From: Griffin, Tim (Contractor)
Sent: 30 August 2024 22:45
To: Harrison, Liz
Cc: Dyer, Tim; Ellison, Mark; Oliveira, Marta (Contractor)
Subject: F/24/97945 - RETIREMENT LIVING APARTMENTS - LAND ADJACENT TO OAK COTTAGE, WINCHESTER ROAD, BOORLEY GREEN, SO32 2DH - landscape comments

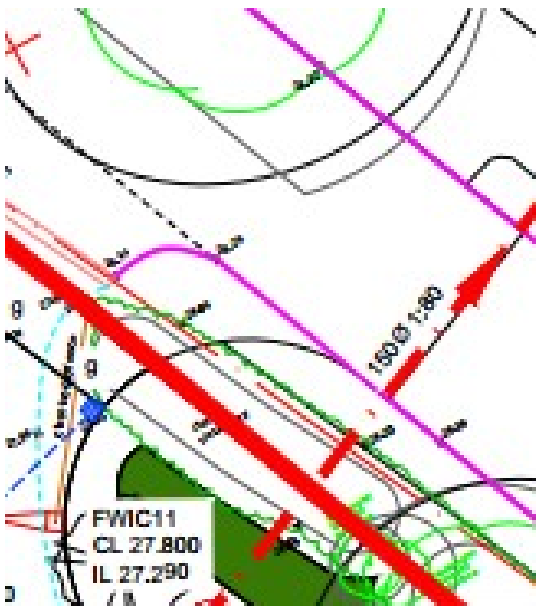
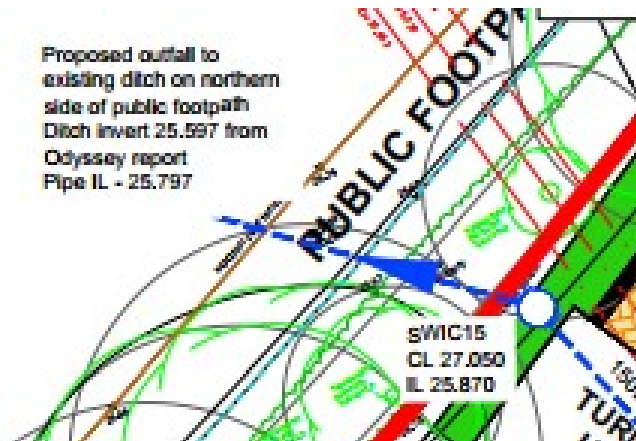
03 Proposal character courtyard - this image demonstrates the scale of the 3 storey apartments and how these will enclose the rear courtyard. This image shows notional tree planting which helps soften the built form.

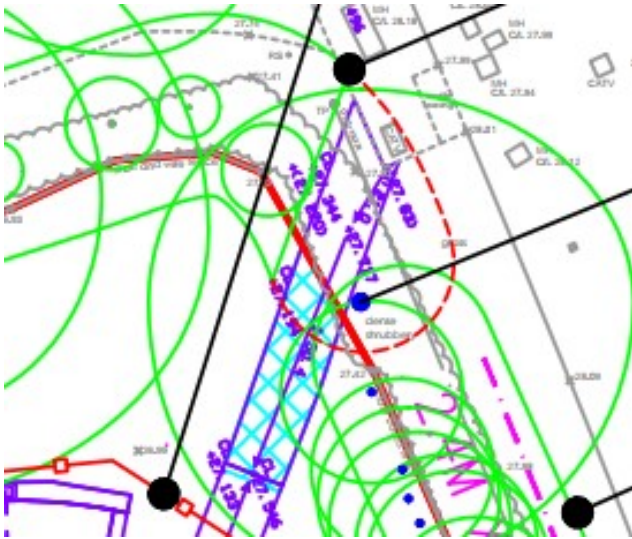
I defer to the Tree Officer on this report but note the loss of a number of fruit trees to enable development of the site.

The suggested pedestrian link to Winchester Road passes too close to the trunk of T21 Oak and should be realigned.

Parking bays 1-3 will lead to potential loss of part of hedgerow T29. This is not acceptable, and the final approved layout must avoid any gaps opening up in the boundary screen along Winchester Road.

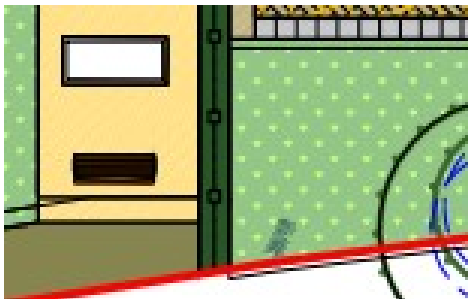
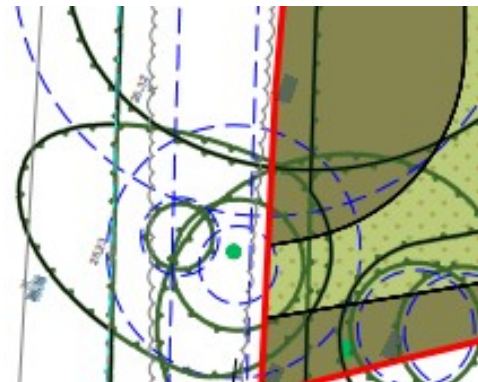
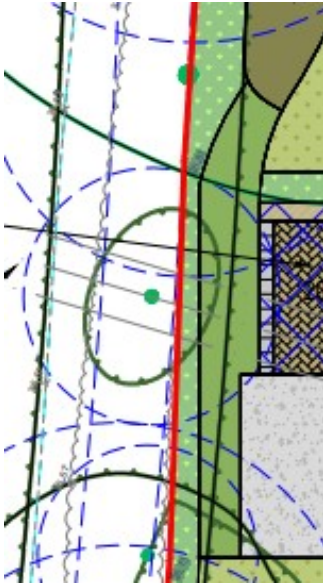
The native shrub planting indicated along many boundaries is welcomed since maintaining and bolstering lower-level boundary screening is crucial to soften the impact of this development. However, there are some odd gaps in the continuity of this planting which should be closed. For example:

I would emphasise the importance of this boundary screen planting being continuous and would ask that the designers check that screening will be maintained and bolstered.

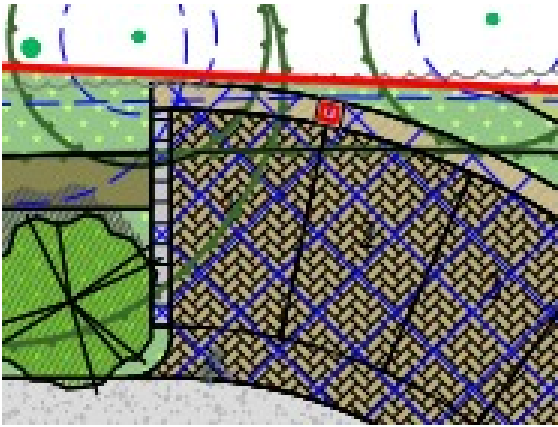
These 4 parking bays may well lead to loss of existing screening and also obstruct any new screen planting - these bays should be omitted or relocated.

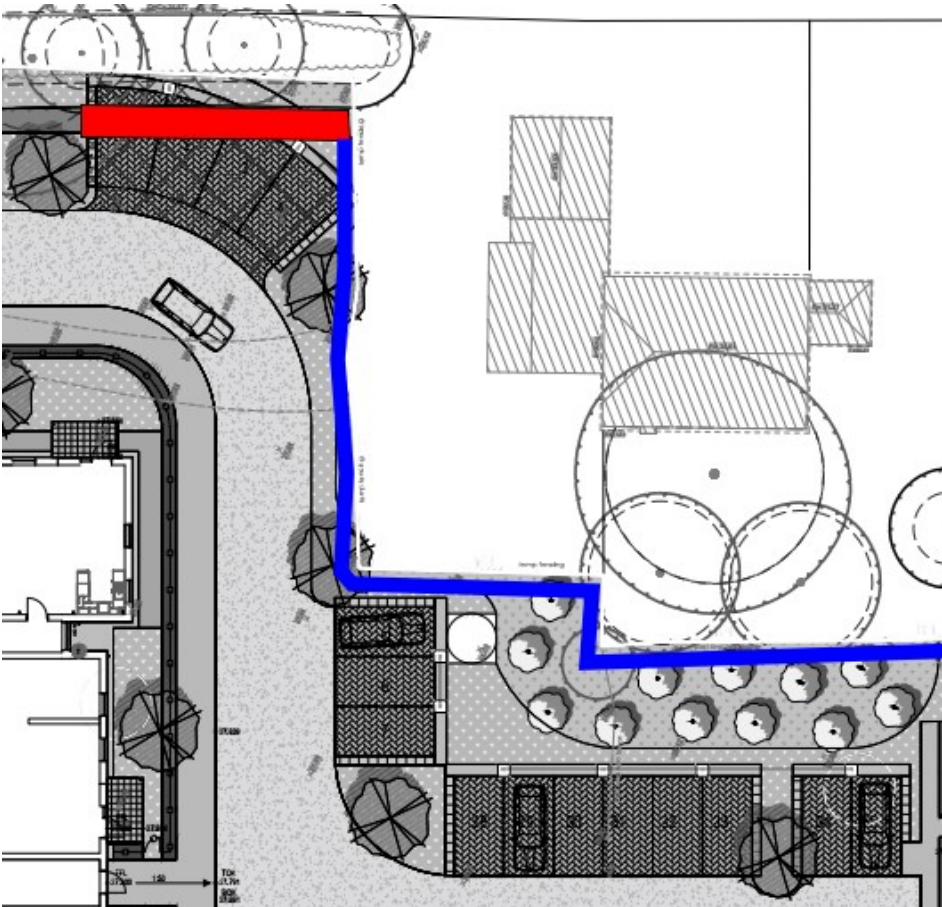
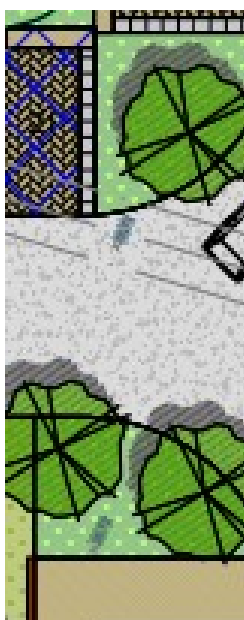
I would prefer to see a native mix hedge running along the SE & S boundaries as per this mark up:

Red = extend boundary screen planting

Blue = native mix hedge to create new wildlife corridor

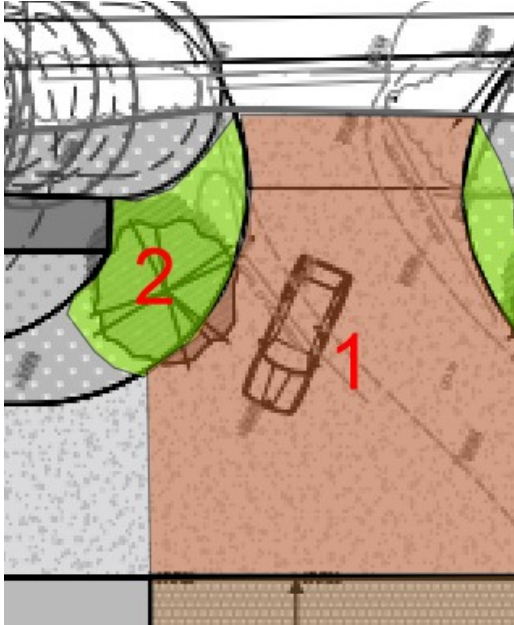
The main entrance is a key area along the identified central vista. I suggest this zone is given an uplift similar to the markup below:

1 = area of contrasting block paving to mark arrivals and slow traffic

2 = low shrubs and groundcover to frame drive

3 = further design work to provide this key area of paving with added interest

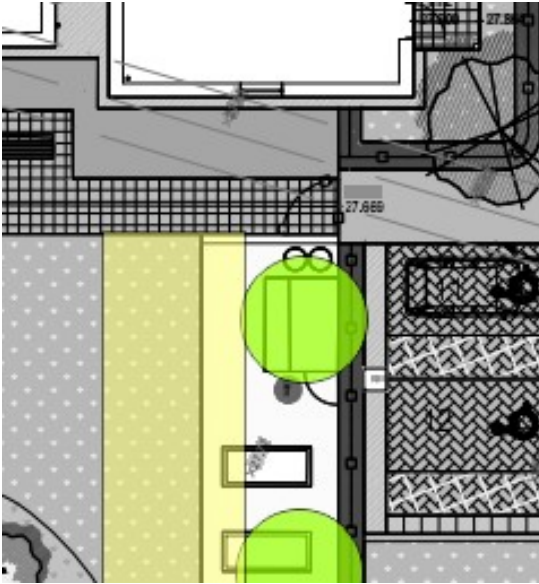
I suggest the growing garden area is moved slightly north to create space for some additional trees as per markup below:

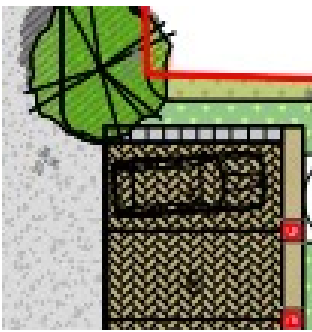
Please clarify what this white square/inner circle represents?
